# Request for Proposals for Site Contractor for the

## Haines Workforce Housing, Jones Point Road, and Medical Center Site Preparation Project

### Addendum 1

SHEET TITLE:  
SITE CLEARING PLAN

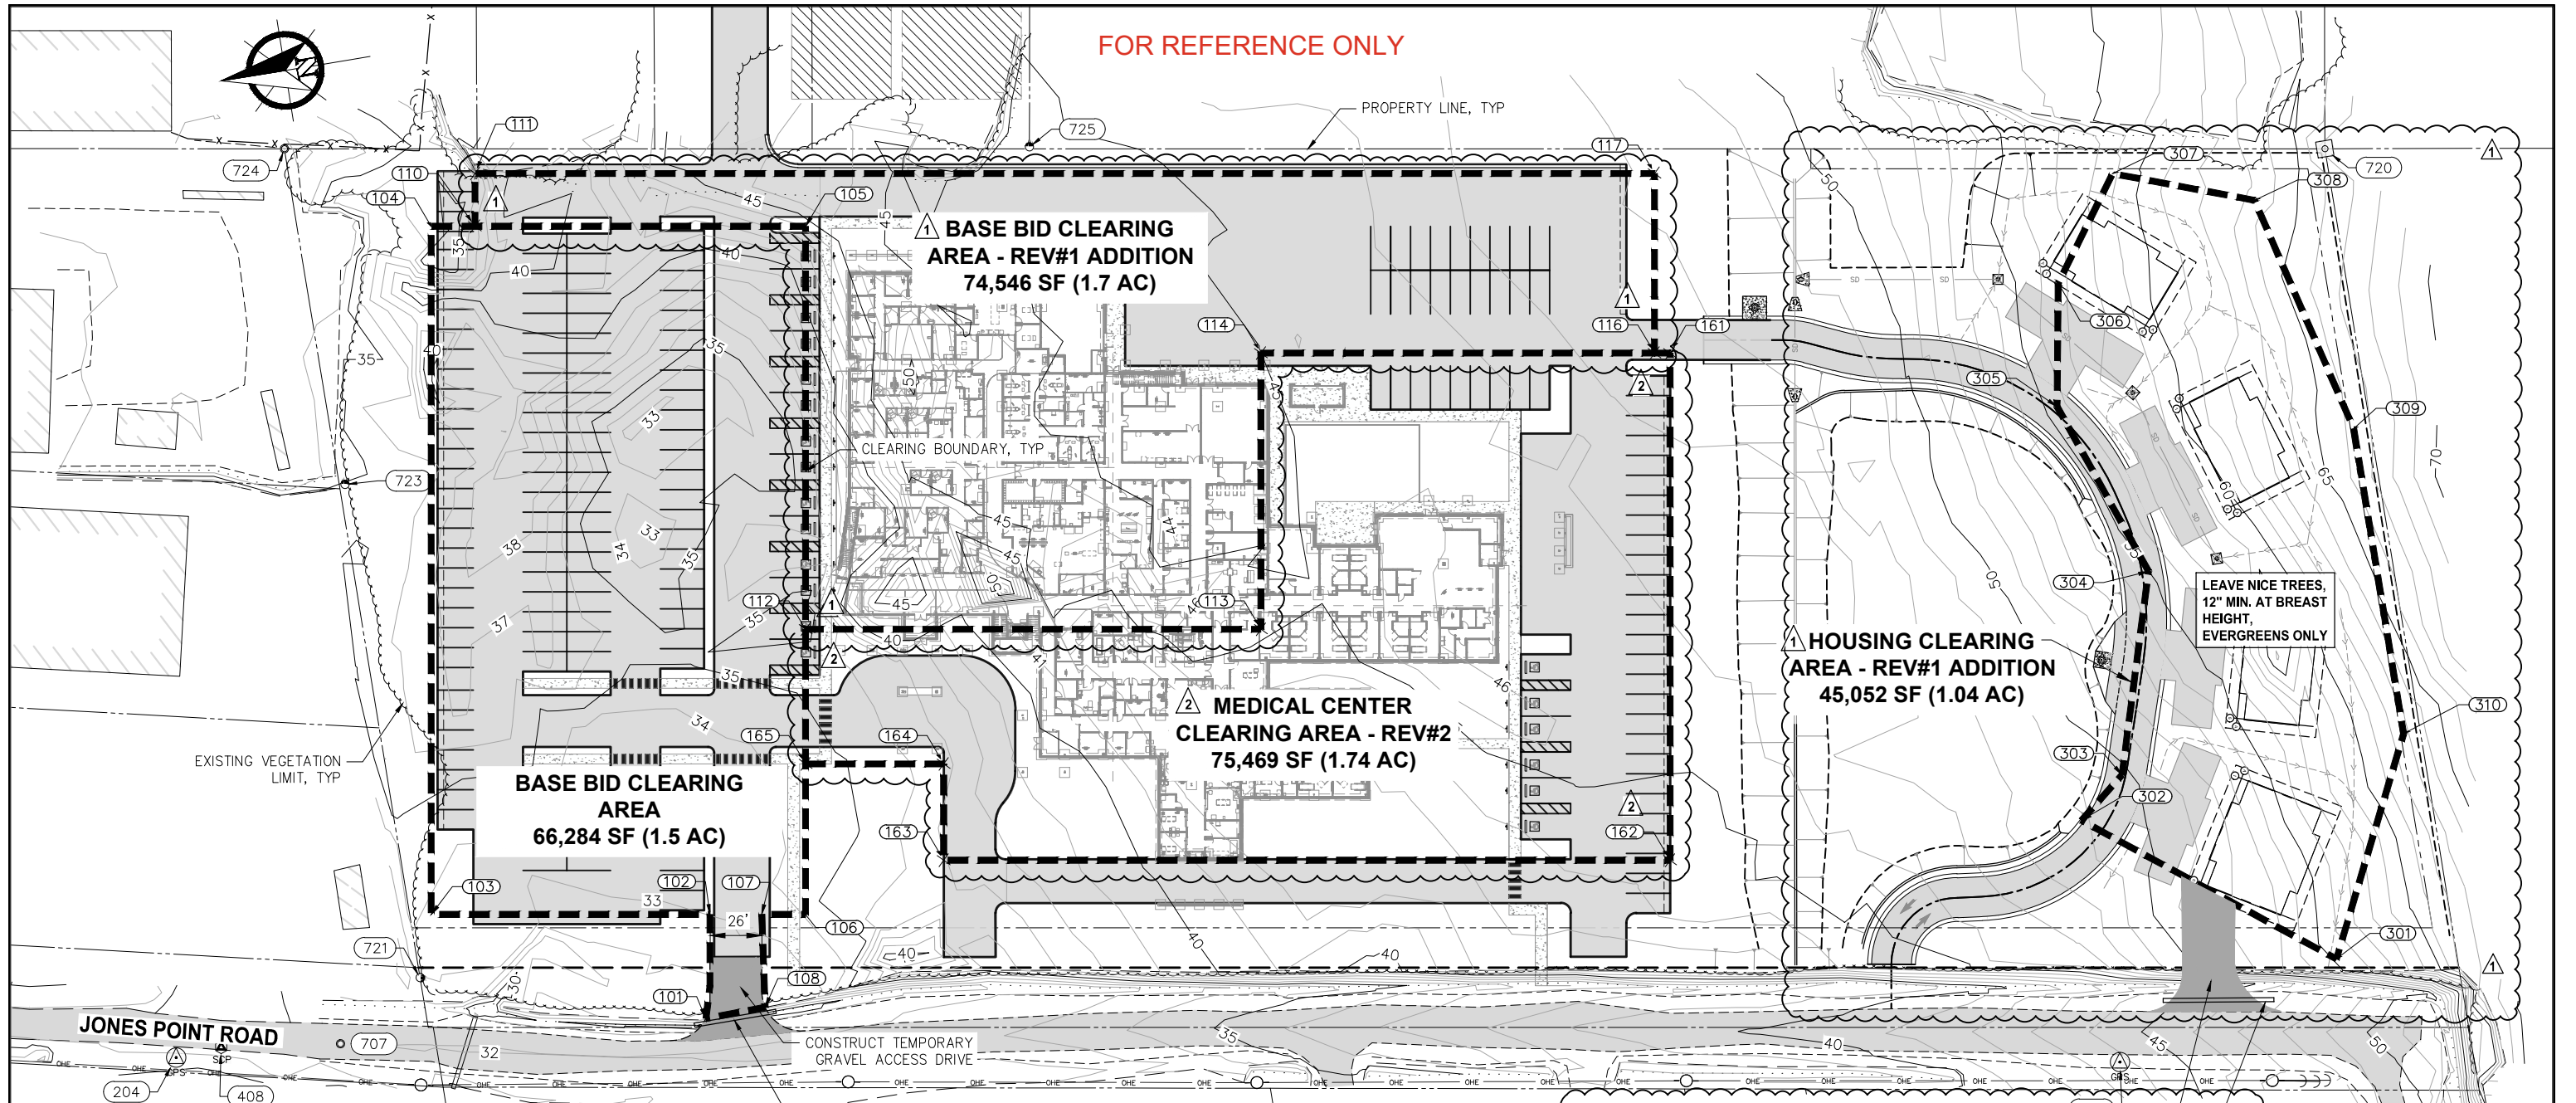
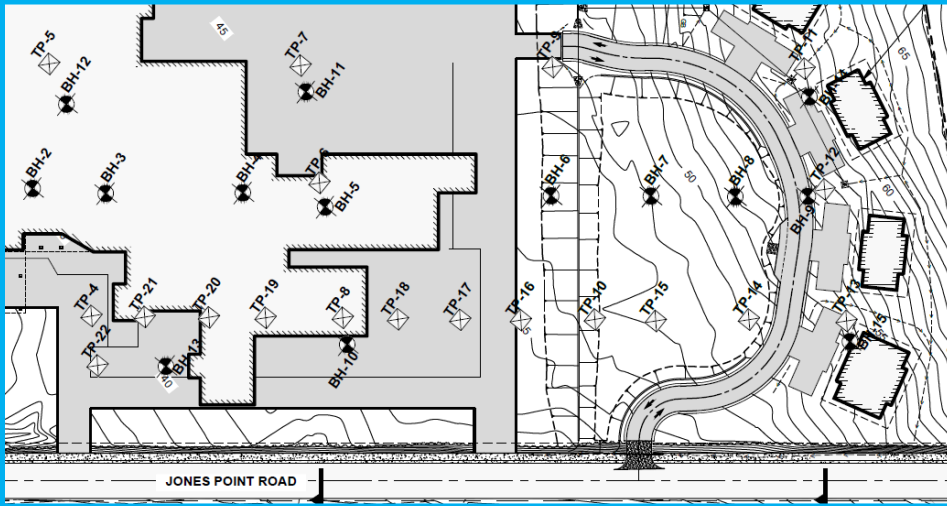
2	Please confirm the work sequencing dates on plan sheet C1.01.	In the best interest of the project work has been re-sequenced so pads for the medical facility foundation shall be ready no later than July 15, 2026. The remaining site work for the medical facility and housing will be the next priority, with the understanding the building pads for housing will be completed no later than August 15, 2026. Following the above work, Jones Point Road is the next priority. SEARHC's assumption is that the selected contractor will have the resources available to complete multiple scopes of the project simultaneously.
3	During the pre-bid meeting it was discussed that there was a prioritization of the medical center site preparation areas, please confirm what that prioritization is.	See response to #2.
4	003132 - Can a geotechnical report be made	Yes, see attached Geotechnical Report in this Addendum.
